3/4.3.7 MONITORING INSTRUMENTATION

RADIATION MONITORING INSTRUMENTATION

TITLE ORIGINAL WNP-2 PARTIAL CONTROL ROOM VENTILATION SYS

TITLE
CURRENT WNP-2 PARTIAL CONTROL ROOM VENTILATION SYS.

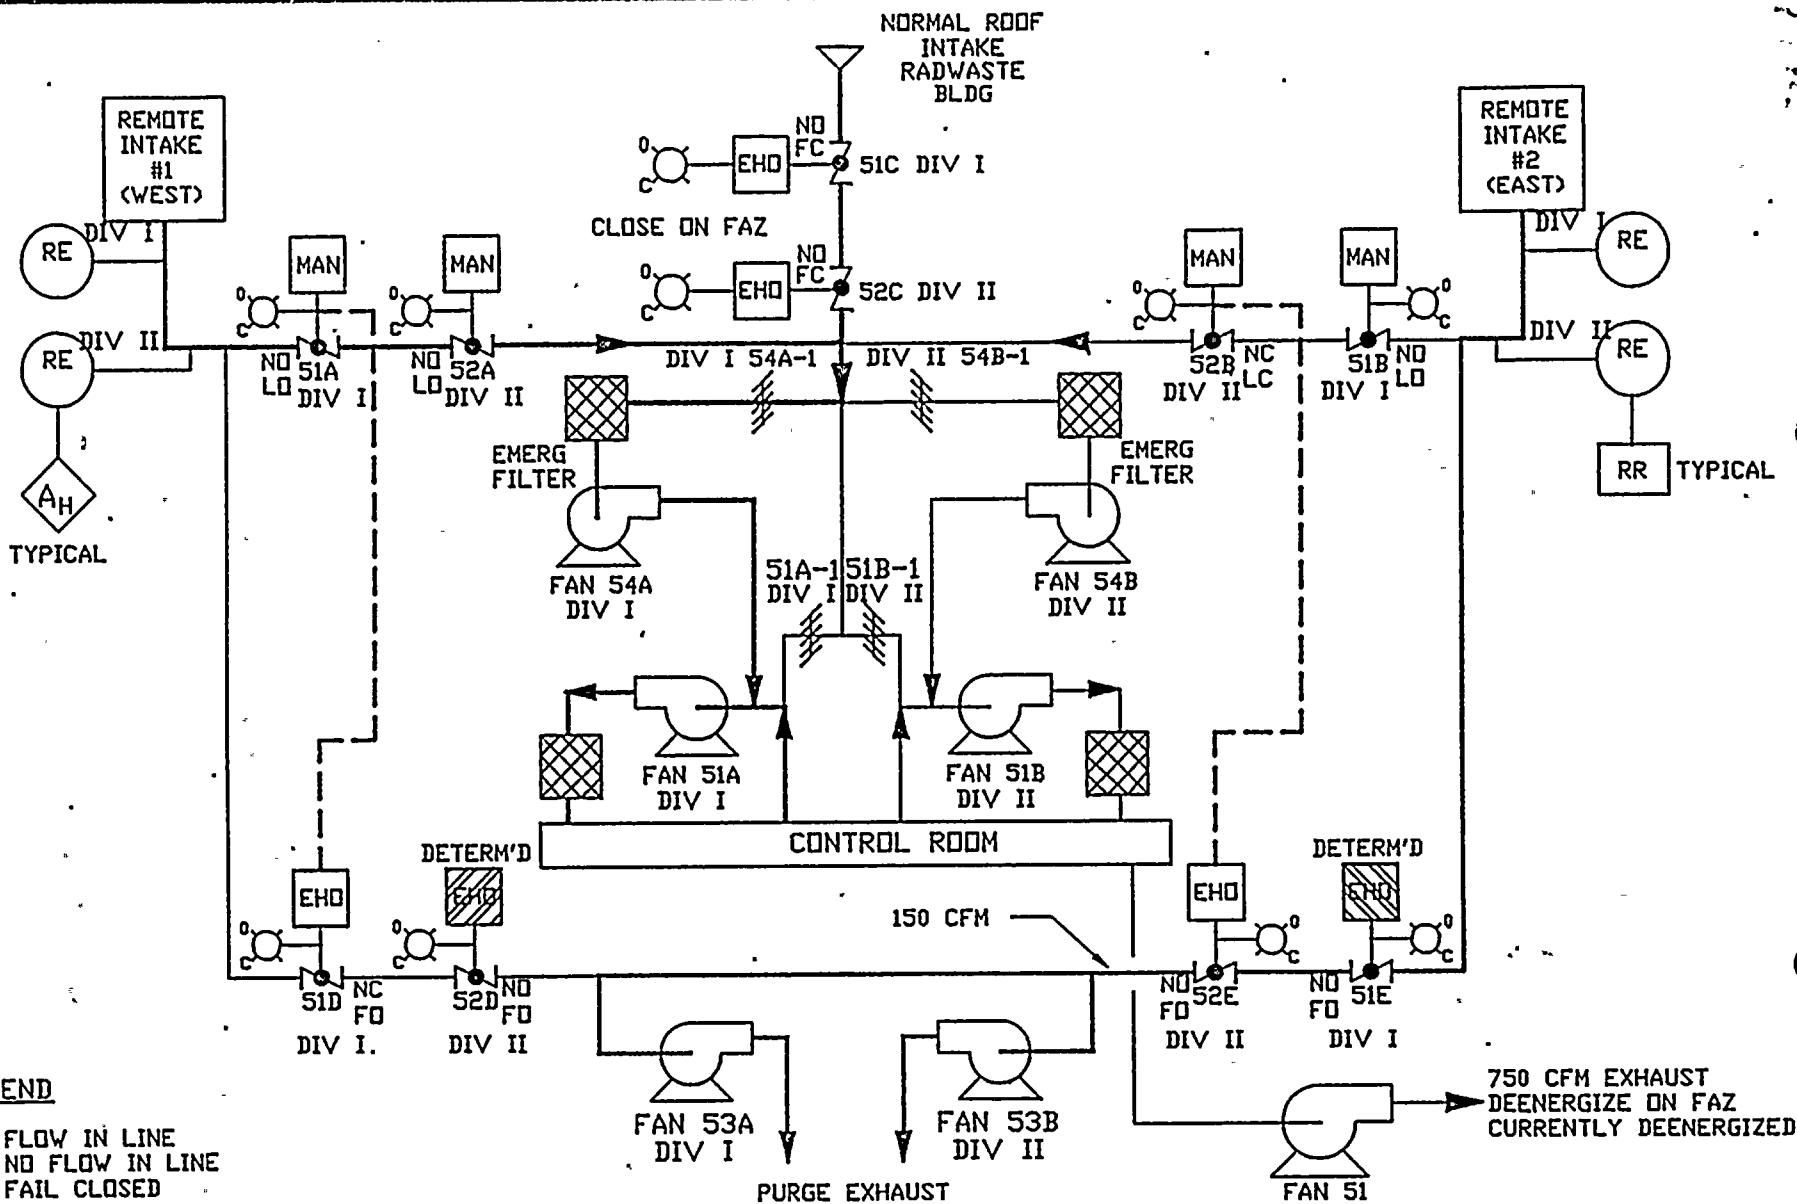
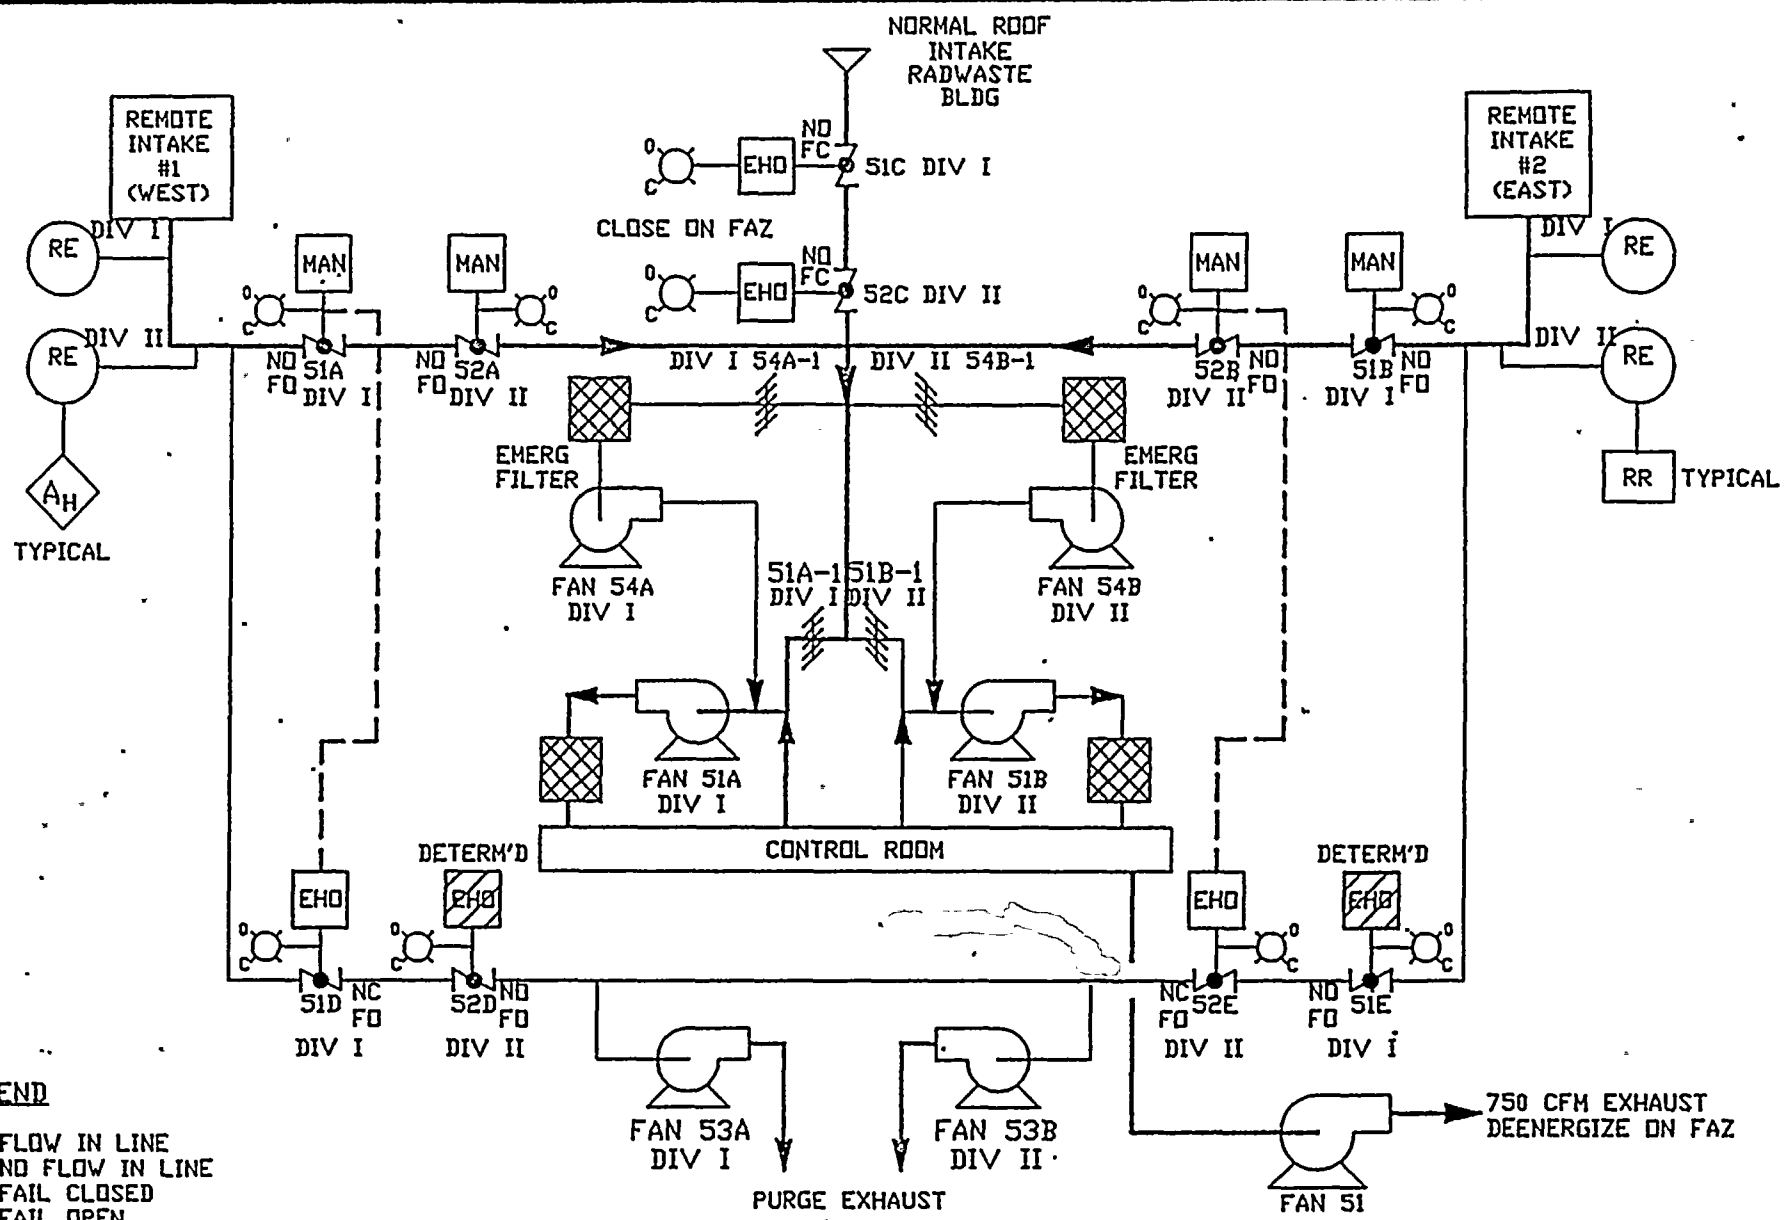
- a. With one of the required monitors inoperable, *manually isolate the associated remote air* ~~place the inoperable channel in the tripped condition~~ within 1 hour; restore the inoperable channel to OPERABLE status within 7 days, or, within the next 6 hours, initiate and maintain operation of the control room emergency filtration system in the pressurization mode of operation. *intake* ₁₂ ¹⁴
- b. With both of the required monitors inoperable, initiate and maintain operation of the control room emergency filtration system in the pressurization mode of operation within 1 hour.

750 CFM EXHAUST DEENERGIZE ON FAZ CURRENTLY DEENERGIZED
